COMPANY: Electronics Tomorrow Ltd.					
MODEL: 699E/F					
PCB VER:	T1.0	TITLE:	SCH	DOC VER:	00
DRN. /DATE: CHENZHAIMING 20-02-2003			DWG NO: 7966E10240		
CHK. /DATE:			IC: RX3310A		
APP. /DATE:			LCD:		
☒ TO FILE ☐ REL			SHEET OF: 3 OF 3

COMPANY: Electronics Tomorrow Ltd.		
MODEL: 724A		
PCB VER:	TITLE: S.C.H	DOC VER:
DRN./DATE: SCM 26/7/03		DWG NO.:
CHK./DATE:	IC: TM8706-K323	
APP./DATE:	LCD:	
☒ TO FILE ☐ REL		SHEET OF: 1 OF 1 EE005

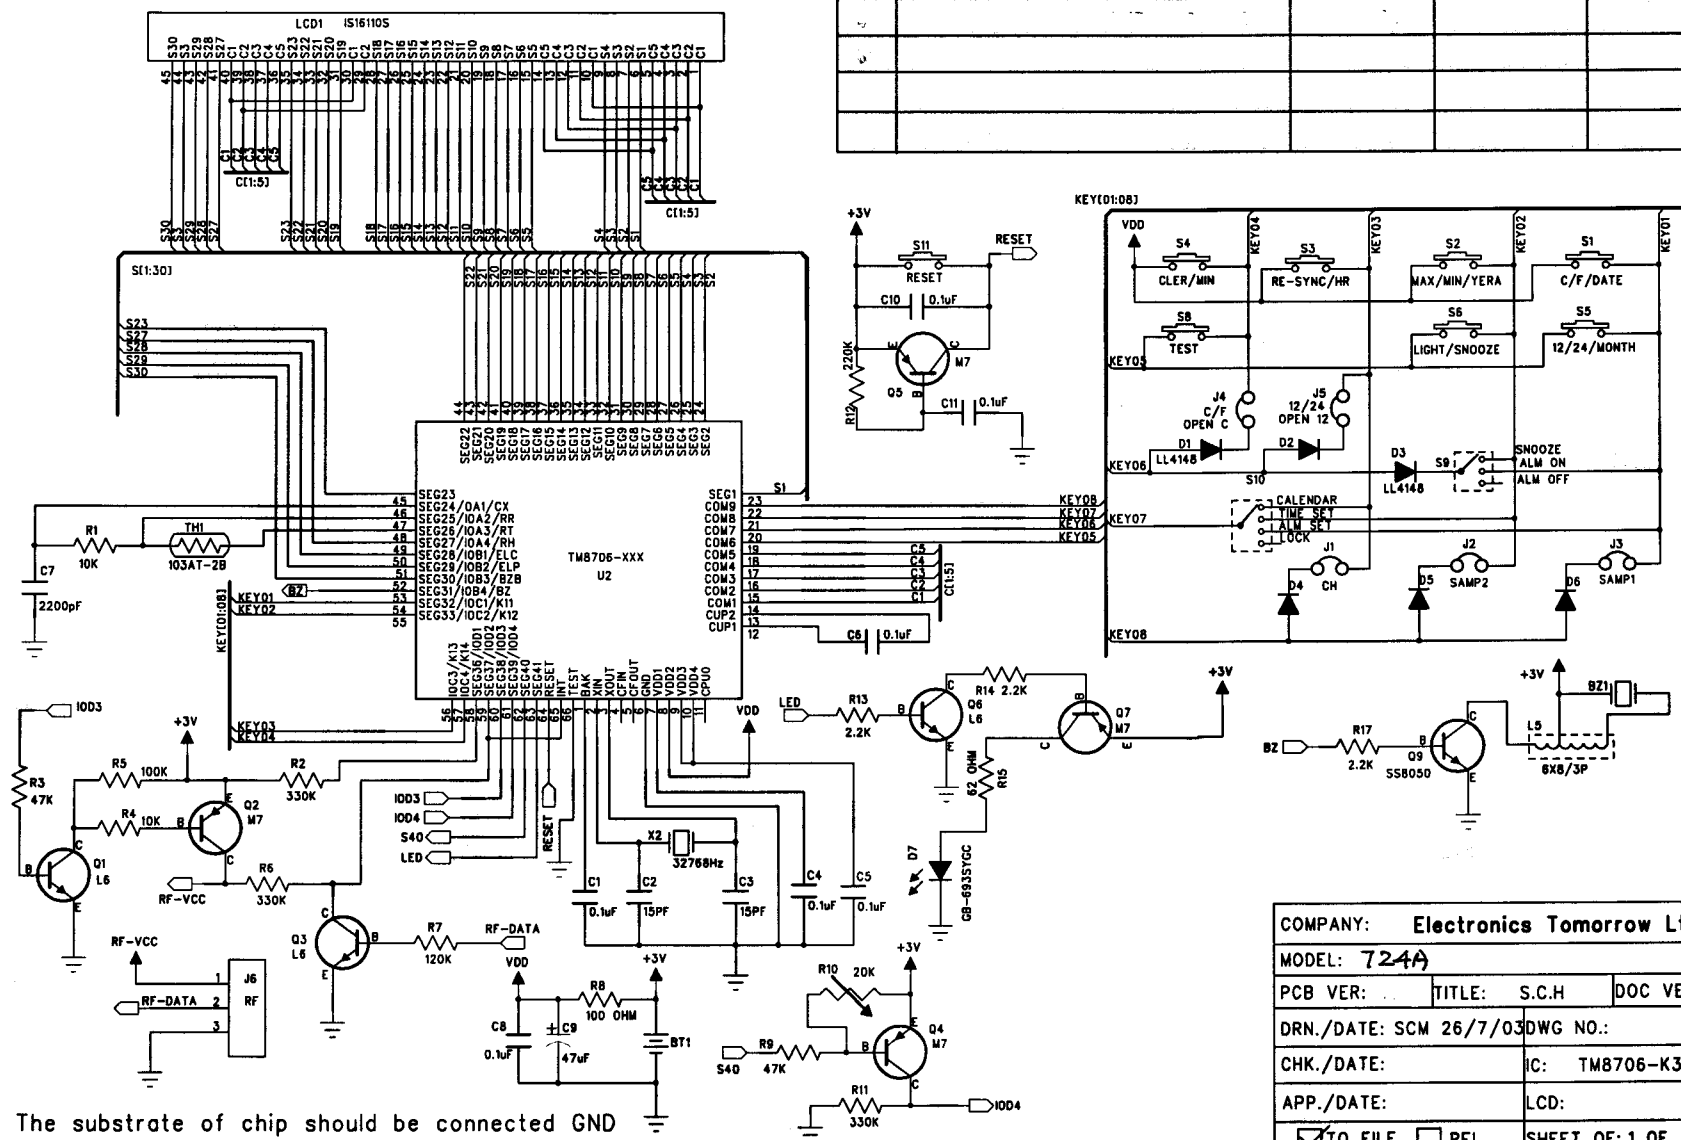
The substrate of chip should be connected GND
